Final Environmental Statement

related to the operation of
**Susquehanna Steam Electric Station,
Units 1 and 2**

Docket Nos. 50-387 and 50-388

**U.S. Nuclear Regulatory
Commission**
Office of Nuclear Reactor Regulation

Fig. 2.3. Water Use Diagram for Susquehanna Units 1 and 2. From ER-OL, Fig. 3.3-1.

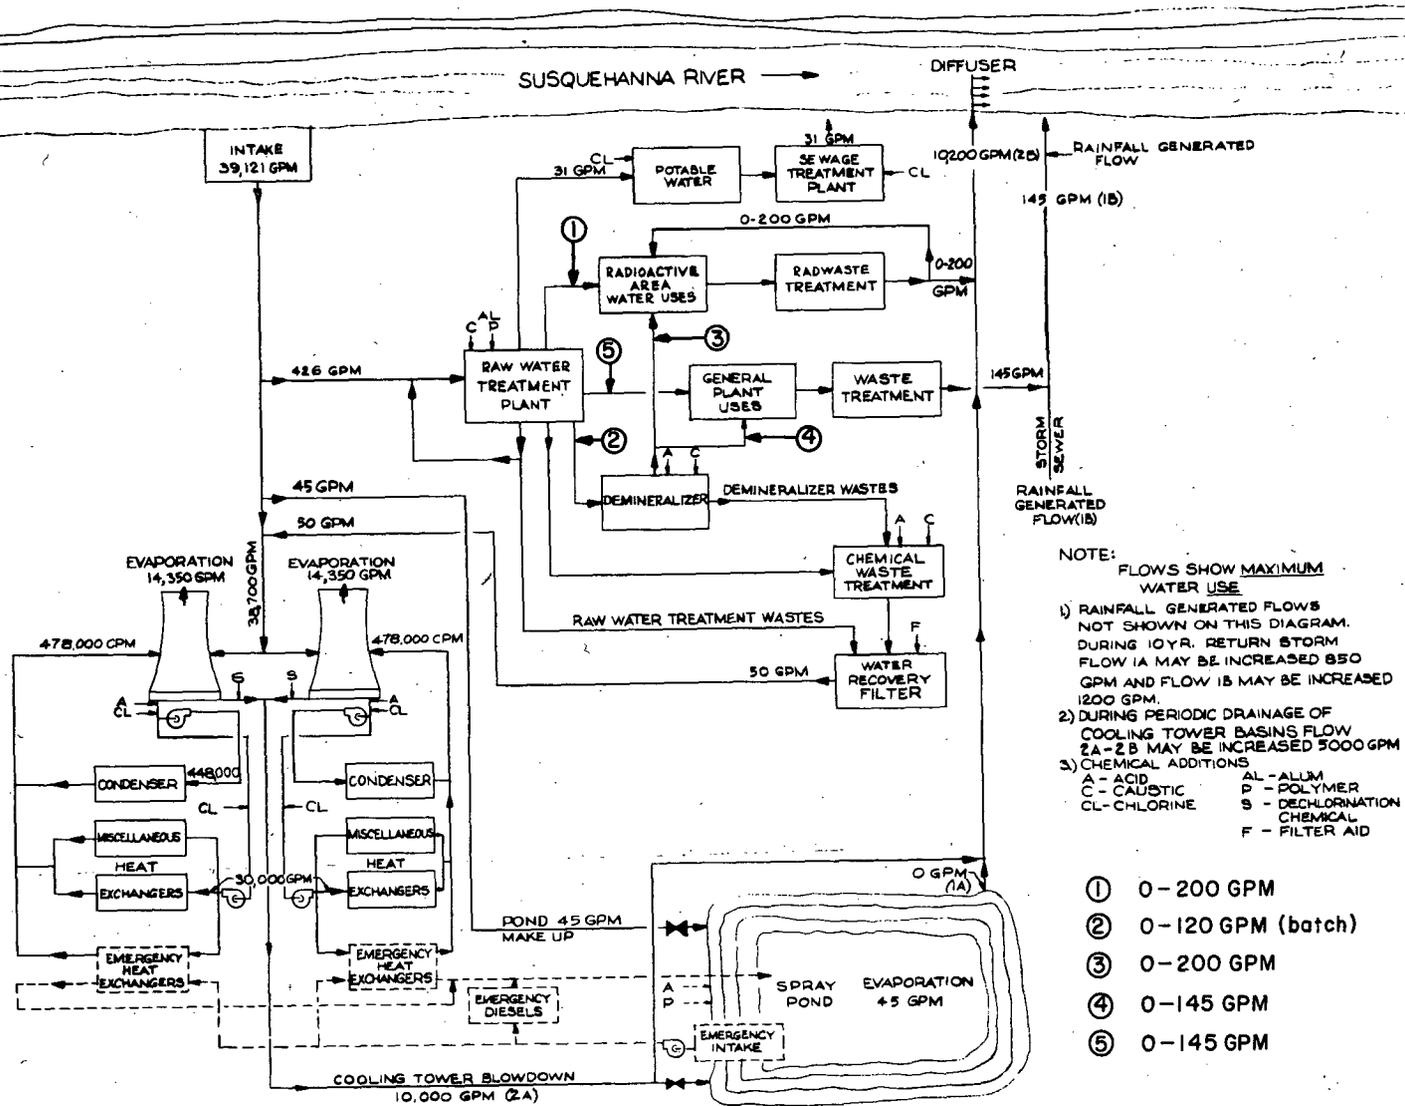
1. Page 2-12, Figure 2.3

Figure 2.3 depicts the Water Use Diagram for Susquehanna Units 1 and 2; however, a water balance cannot be calculated for many of the unit processes shown on the diagram due to insufficient information. For example, it is impossible to determine the makeup of the waste treatment discharge since the flow rates of the demineralizer and raw water treatment plant discharges are not indicated.

Figure 2-3 does not clearly illustrate whether the sewage treatment plant effluent is discharged into the Susquehanna River. The plant is not described in sufficient detail. The lack of design or operation mode does not give the necessary assurance that it will operate efficiently at 1/3 capacity without adverse impacts upon the river. Many treatment systems fail when they are not operated at capacity.

Since the DES was published, the applicant has indicated that the parking-lot pond has been deleted. Figure 2.3 has been amended accordingly. The only water discharged to the river through the drainage ditch will be rainfall-generated water and treated waste water from sumps and drains in non-radioactive plant areas (e.g. condenser, pumphouse, diesel generator and electrical equipment areas), estimated as 9.1 L/s. Oil will be separated and recovered where necessary. The waste water from raw water treatment (essentially clarified water) will be recycled to the condenser cooling system together with neutralized and filtered demineralizer waste. The total water so recycled is estimated as 3.15 L/s. The average demineralizer waste flow was estimated in the ER-CP as 0.21 L/s.

Figure 2.3 has been modified as a result of the design change.

1. Section 2.3.3, pg. 2-11 - Figure 2.3, Water Use Diagram has been revised per the NPDES permit. The parking area hold-up pond has been deleted (see revised Figure 2.3, attached)
2. Section 2.3.4.1, pg. 2-11 - On "line 1" - The monitoring schedule ranged from twice weekly to quarterly. On "line 2" - The monitoring by Ichthyological Associates since 1971 has been weekly instead of daily. Line 8 should read total iron "and fecal coliforms". Figures 2.5 and 2.6 are reversed.
3. Section 2.5.1.3, pg. 2-22 - Add to line 12; "An American peregrine falcon was observed in 1973.:"
4. Section 2.4.2, pg. 2-11 - Local Meteorology

Fig. 4.1. Exposure Pathways to Humans

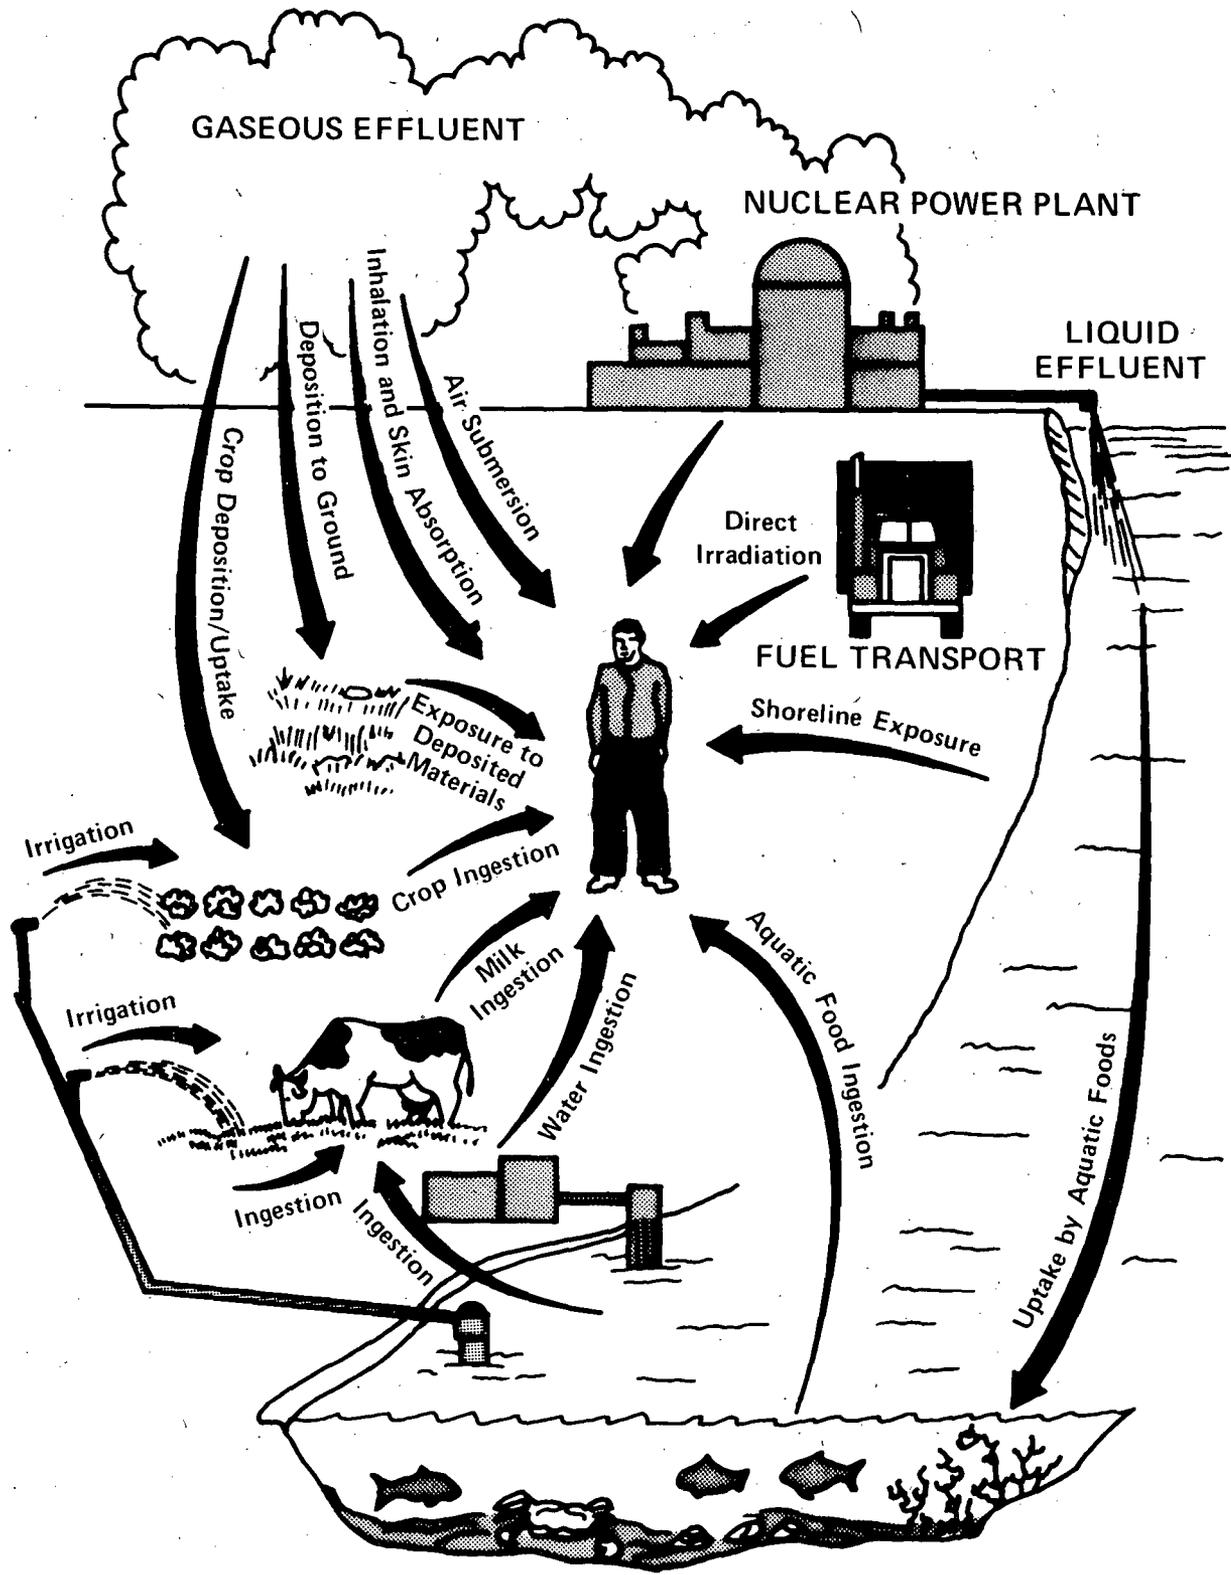
We agree with the staff that the applicant should monitor groundwater both upgradient and downgradient on a monthly basis. We note that the potential for radionuclide contamination of groundwater is implied on page D-1 of Appendix D.(item 1.6); however, figure 4.1 (p. 4-13) does not indicate groundwater as an exposure pathway to humans.

Fig. 6.1.4-6

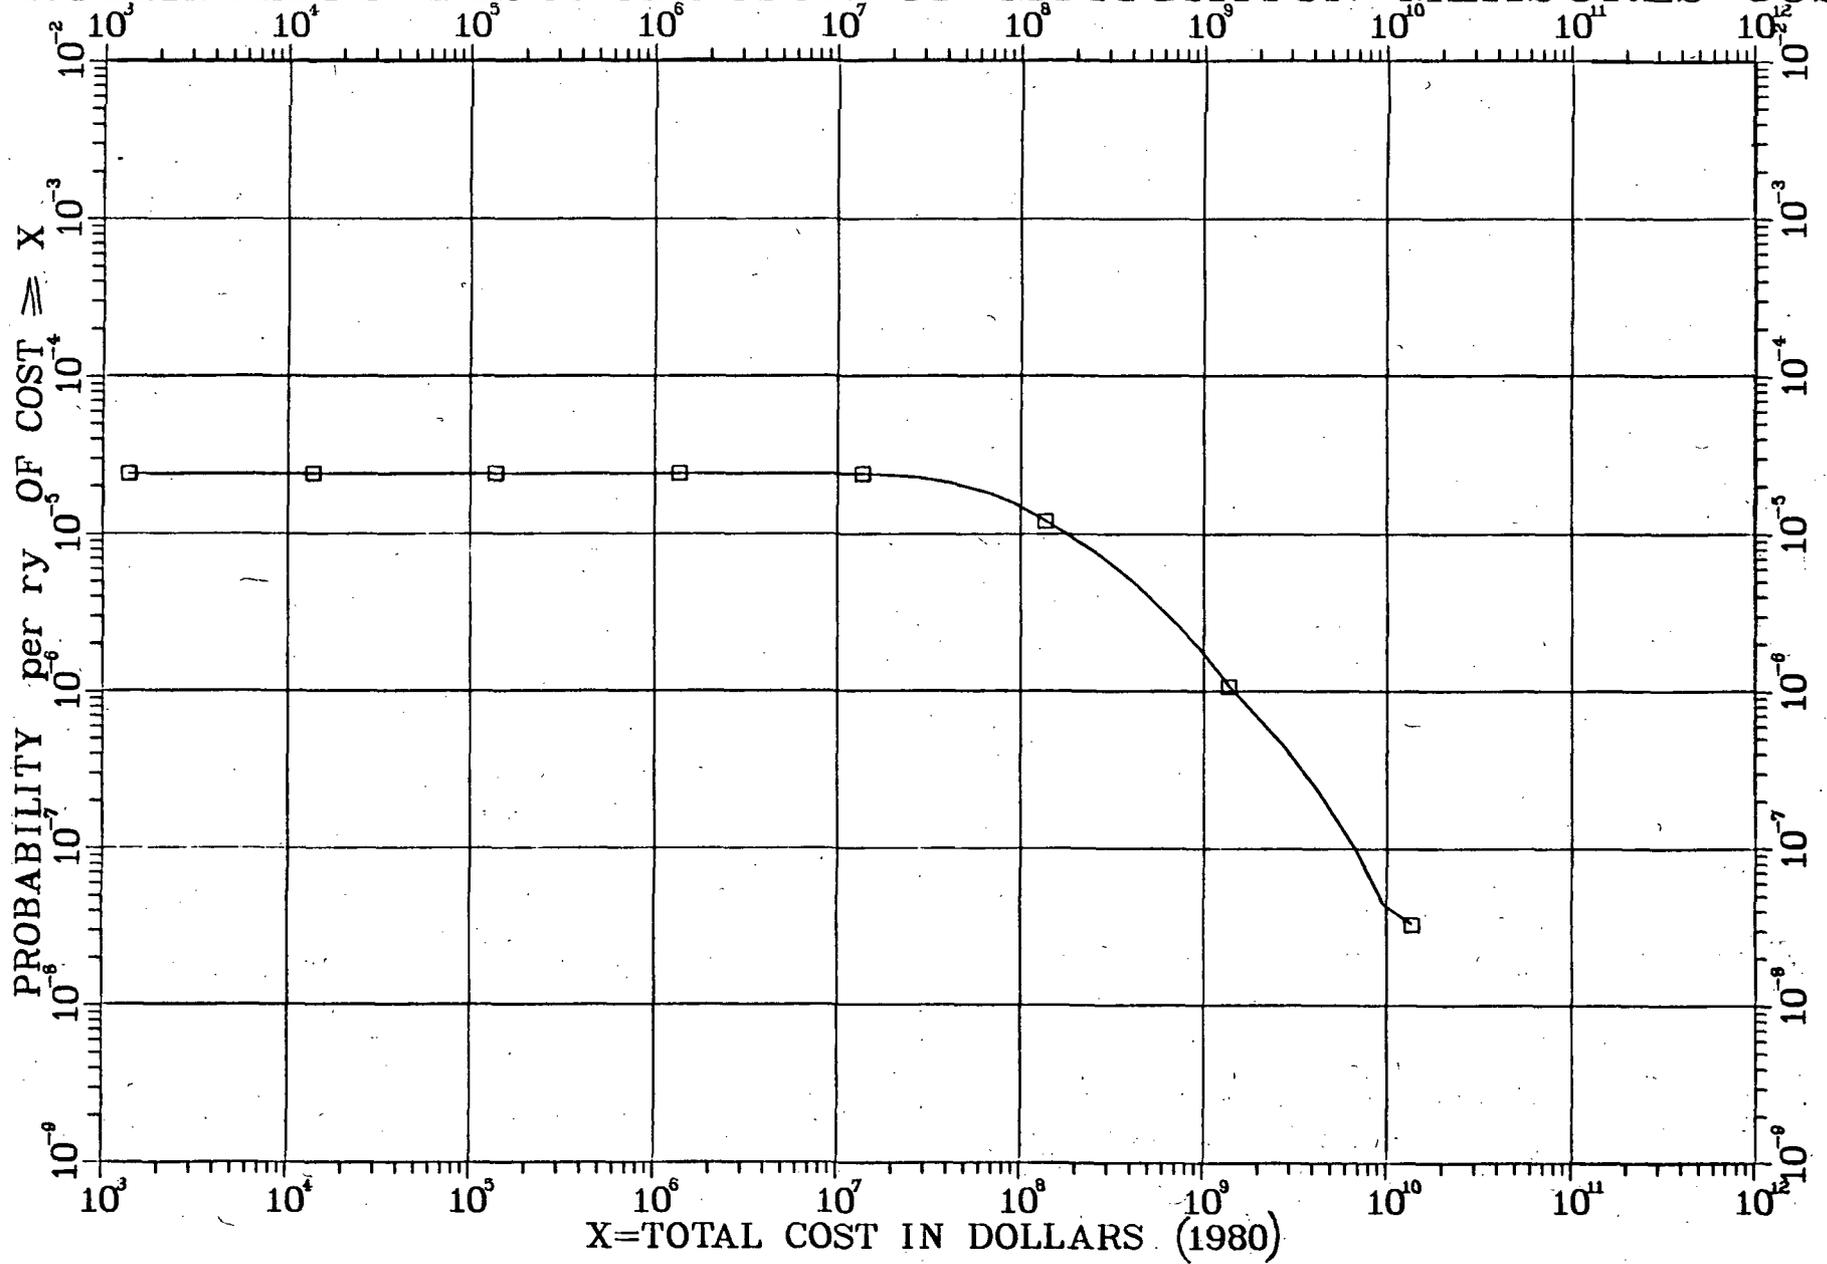
21) The consequences of the accident at TMI should also be included in figure 6.1.4-6.

Accurate cost figures for TMI-2 accident mitigation measures are not available at this time. It is the staff's judgement, however, that these costs would not exceed those shown in Figure 6.1.4-6.

Fig. 6.1.4-7

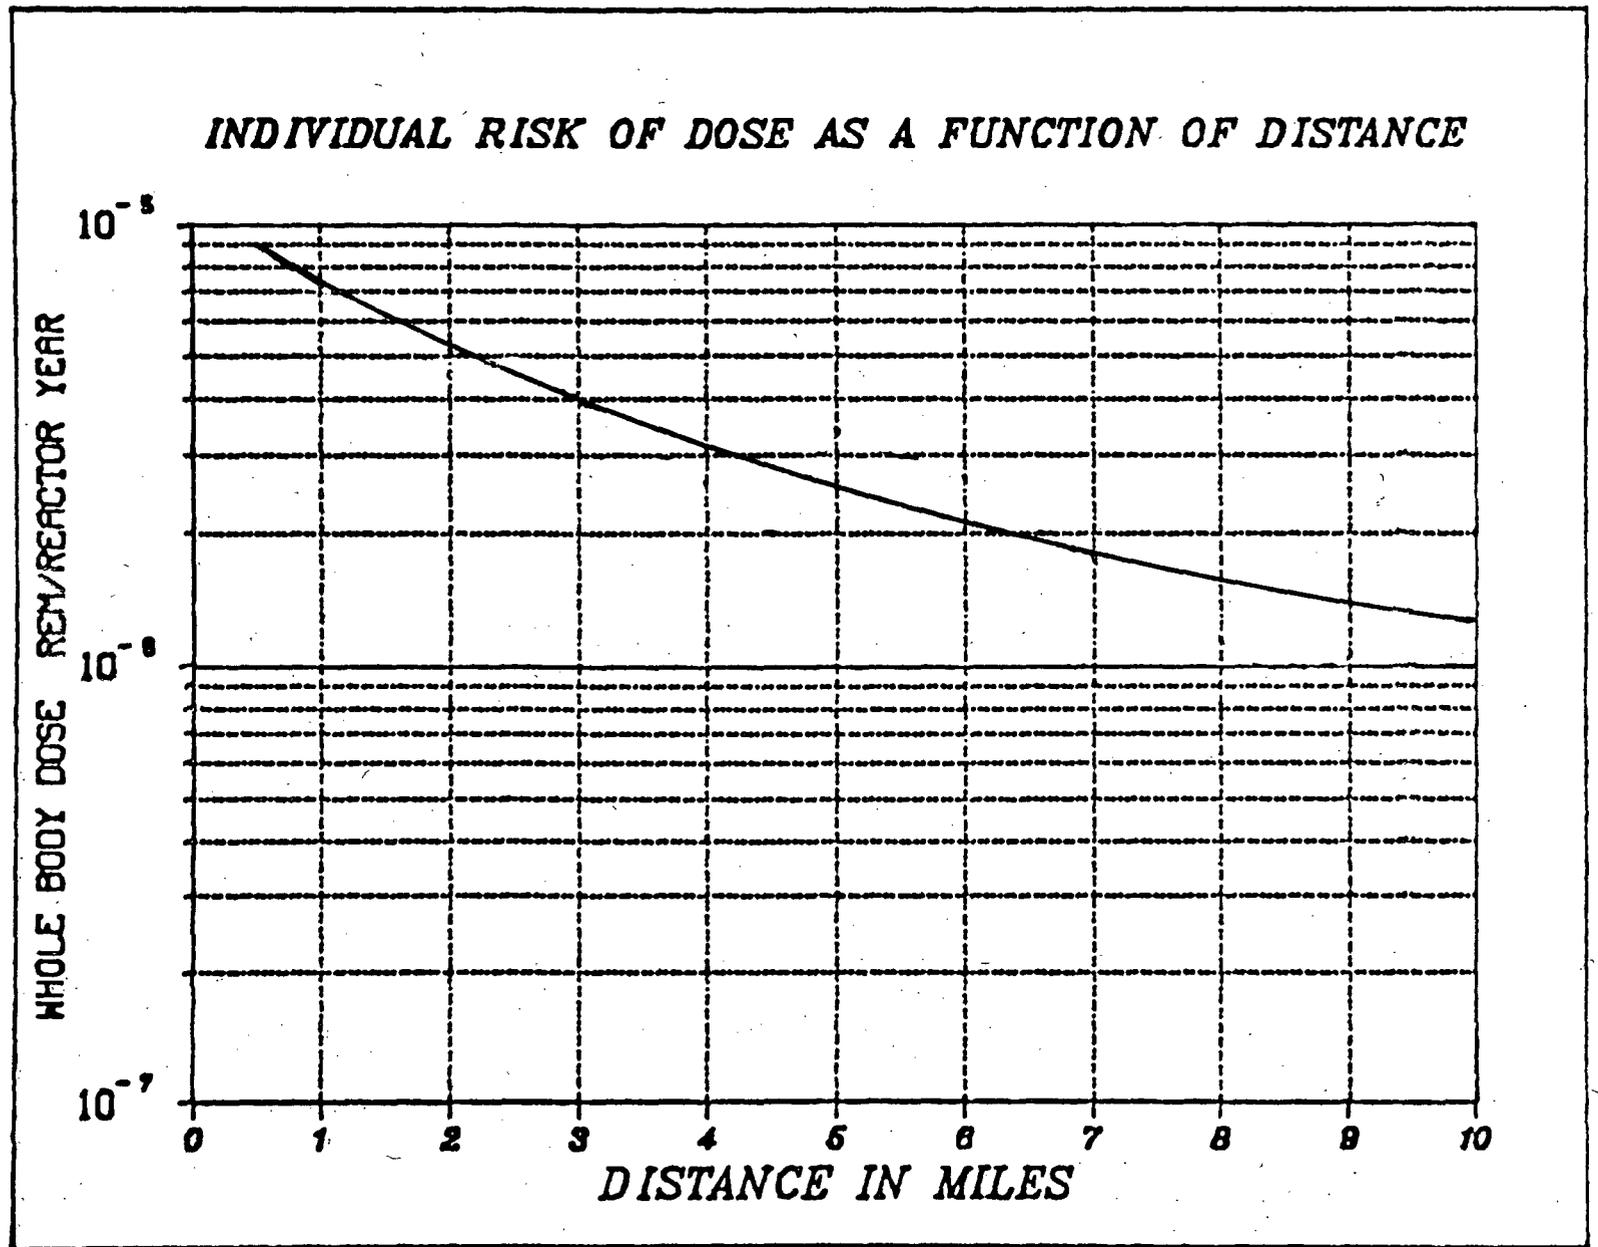
- 22) The maps are of the poorest quality and should be improved so that they could be read more clearly. (figures 6.1.4-7 and 6.1.4-8)
- 23) Add a map or maps that would show the isopleths of costs of mitigation.
- 24) The speed of groundwater movement seems to be highly underestimated, especially in the local glacial material, and especially under saturated ground conditions.(6.1.4.5)
- 25) There should be references sited of past work or studies that show effective isolation of radioactive contaminants in groundwater. (6.1.4.5)
- 26) This supplement should address site-specific conditions and not generic conditions as it seems to have done.
